NSW Independent Planning Commission
11 Gibbons St
Review of Mechanical Ventilation System

ISSUED 24JUL2019

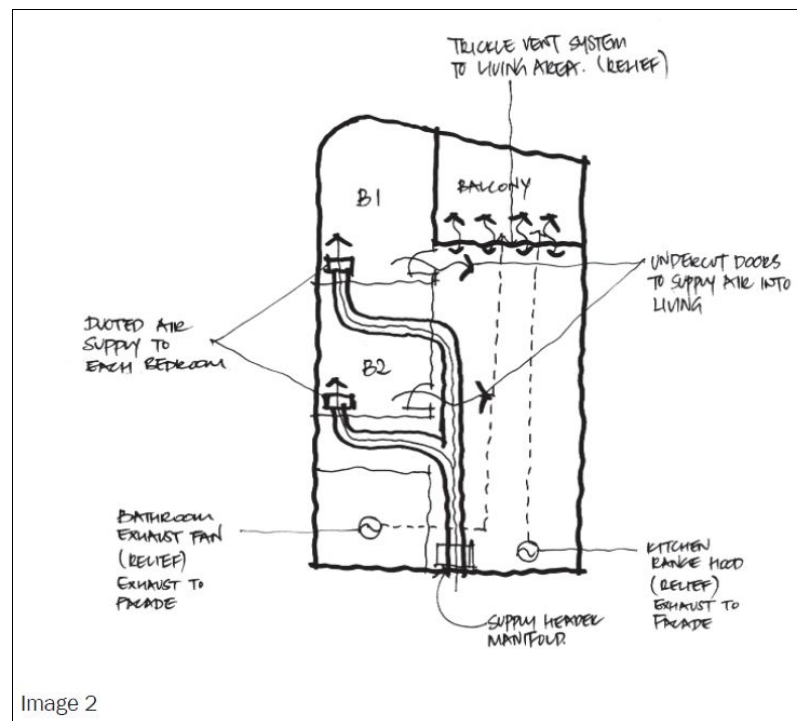
The sketch in Image 2 above indicates that the Invisivent trickle ventilation system is being proposed as a path for relief air, with supply air being provided by the COAS system. However, a review of the Invisivent brochure indicates that the product seems to be designed to be used in a supply configuration. The following is an extract from the online specification brochure (italics are the author’s):

How well would the product perform in a relief air path role, ie., when the kitchen and/or bathroom exhaust systems are off, but the continuous mechanical ventilation system is operational, and supplying outside air to the bedrooms, that are then distributed to other rooms via the undercut doors?
